RELEASE FOR
CONSTRUCTION
AS NOTED ON PLANS REVIEW
DEVELOPMENT SERVICES
LEE'S SUMMIT, MISSOURI
02/01/2021

LOT 126 WOODSIDE RIDGE
2115 NW KILLARNEY LN
LEES SUMMIT , MO 64081

PLAN NO.
SF-7008

FIRST FLOOR PLAN
1/4" = 1'0"

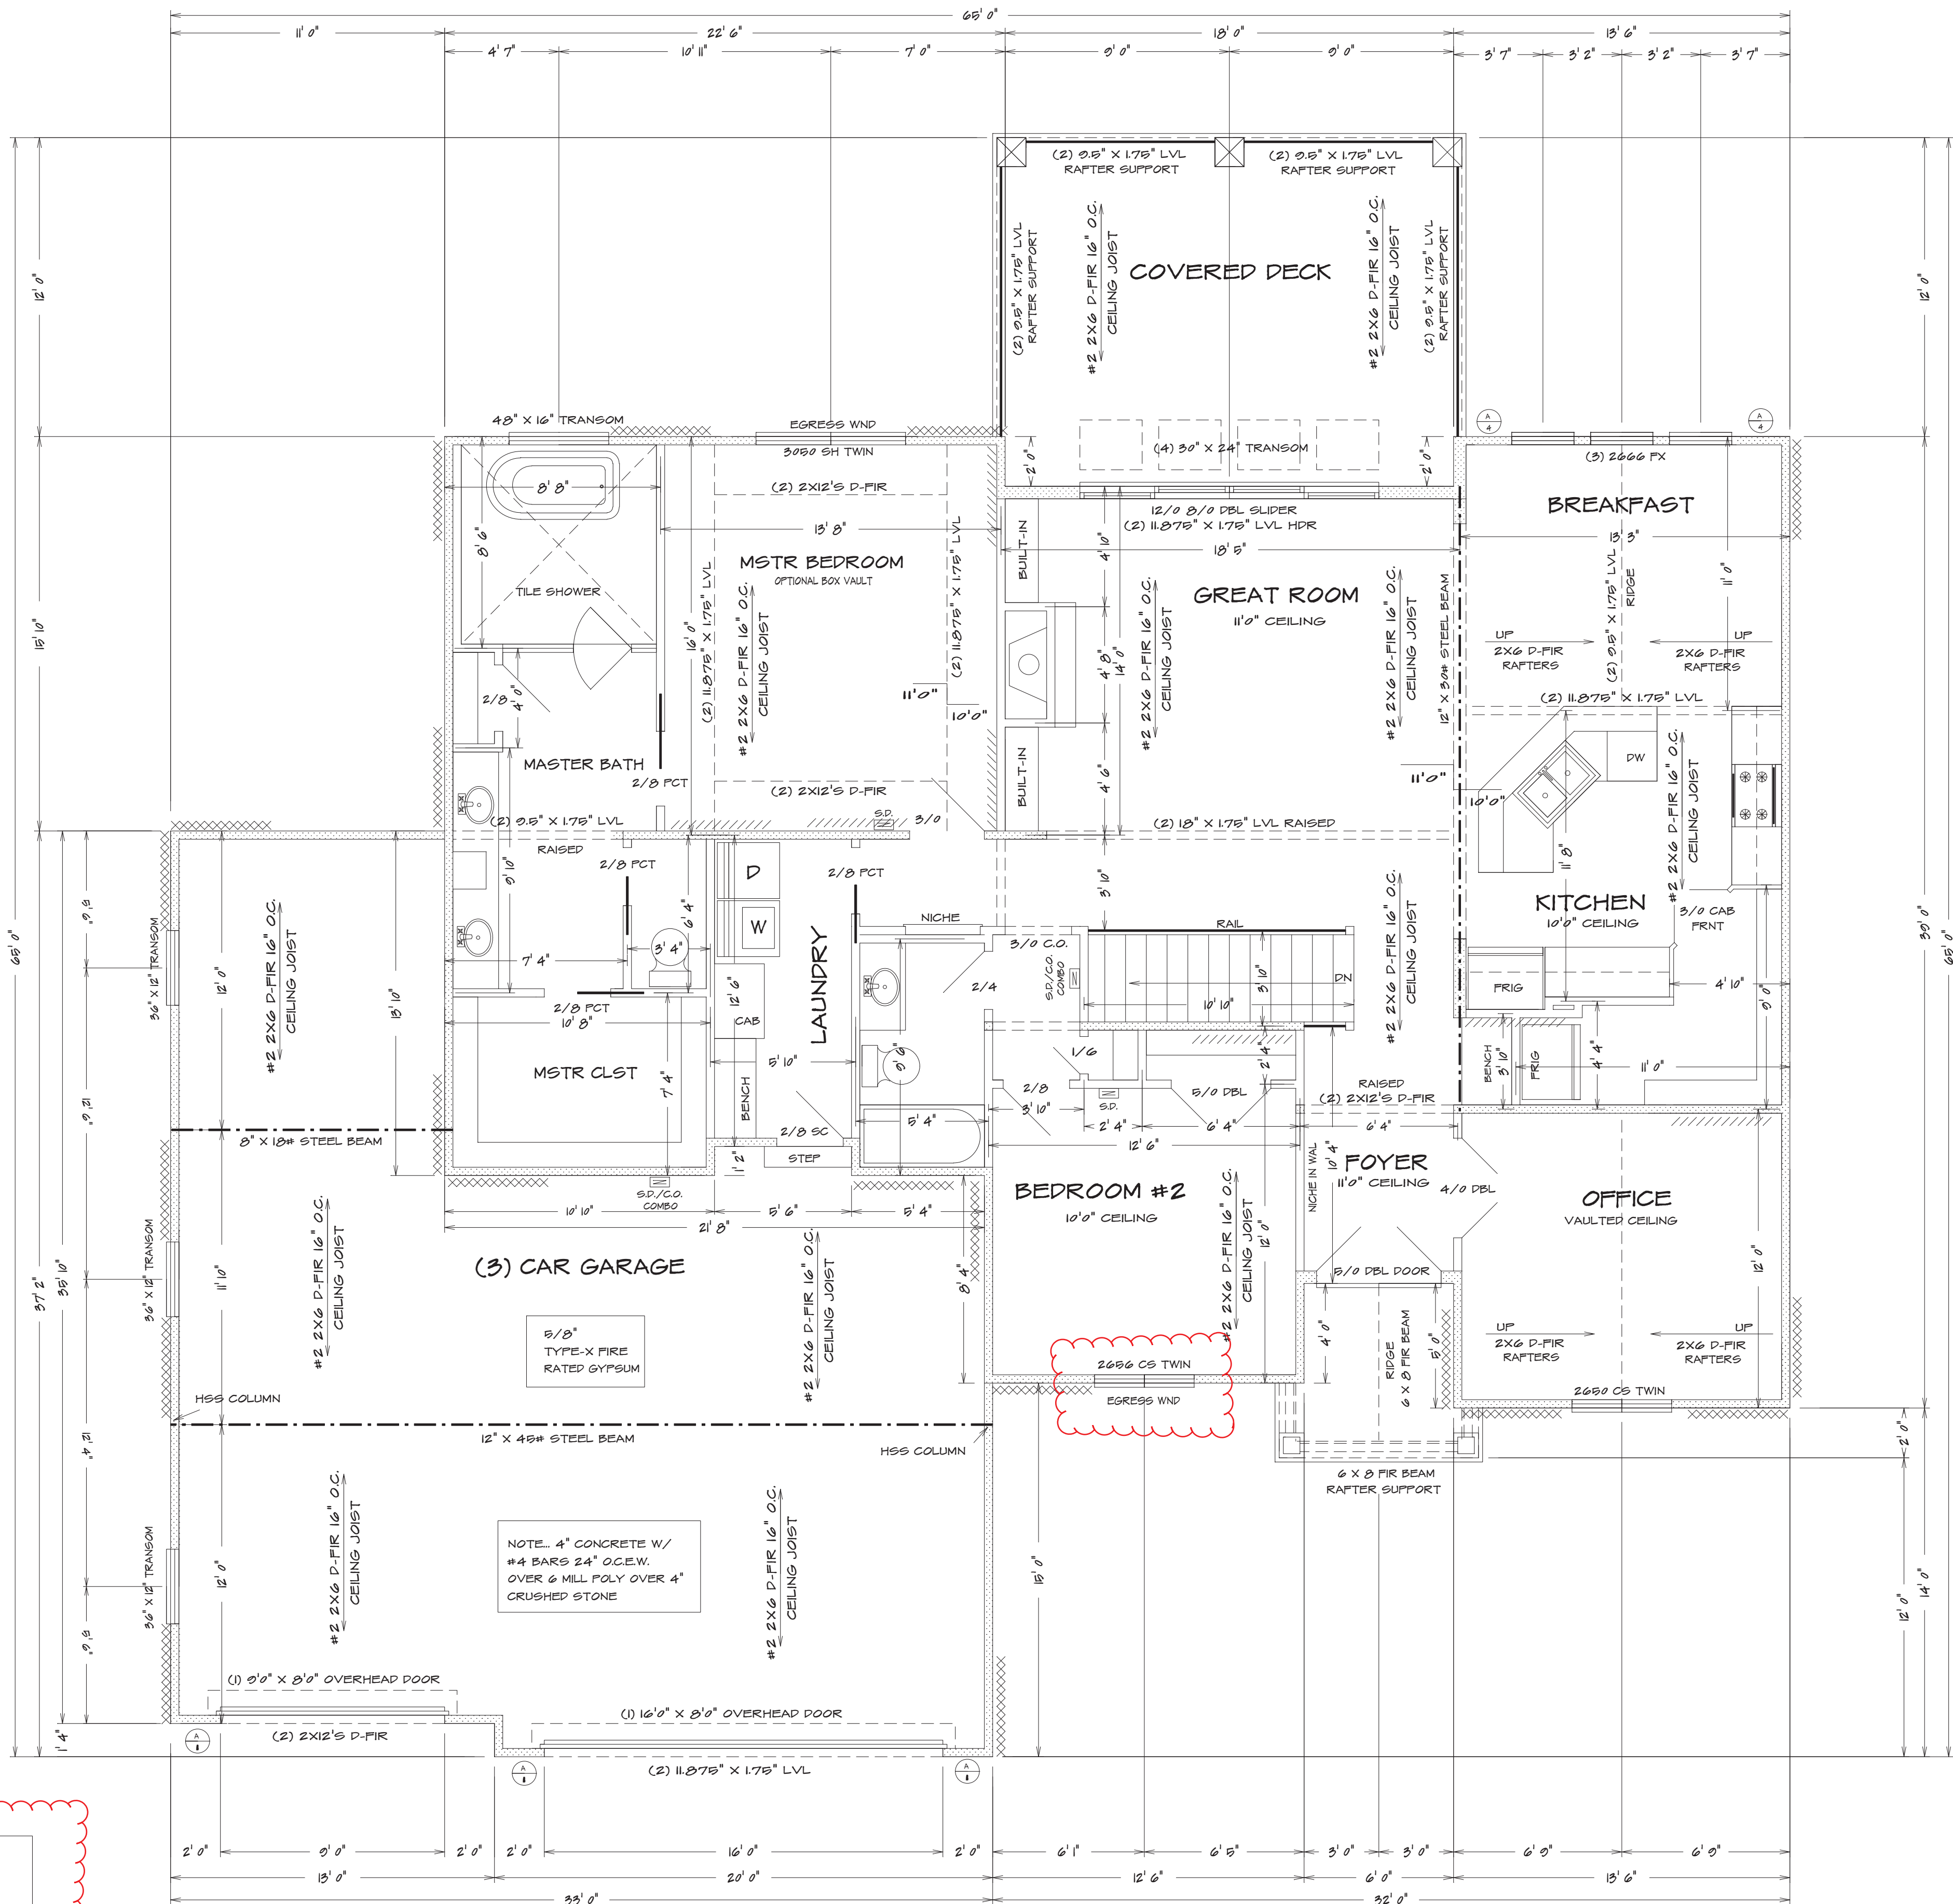
2. Reinforcing bars shall be permitted to be bonded together by the usual steel tie wires or other effective means. Where multiple concrete-encased electrodes are present at a building or structure, it shall be permissible to bond only one into the grounding electrode system." Proper lap splices are required
